SERVICE LETTER 253

Horizontal Stabilizer Spar Cracking At Finlets

Aircraft Makes/Model(s):	Float Model(s):	Compliance: Mandatory	By: MAS
Air Tractor AT-802 & AT-802A	10000A	Part Number: 1012347	Approved: DRH
		Date: 7/27/2026	Revision: H

Figure 9
Alternate Skin Patch

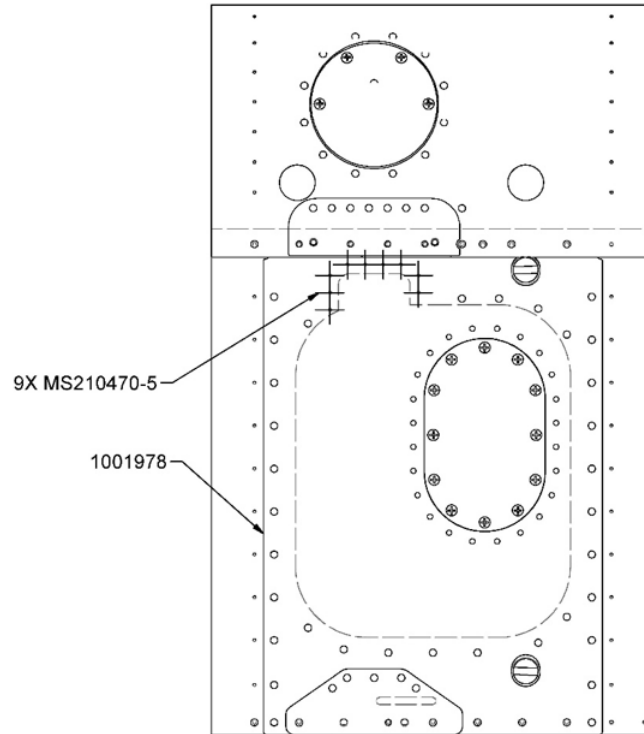
Note: Service Letter kit utilizes an alternate skin patch to accommodate prior modification of stabilizer skin. (1001978 in place of 1001971)
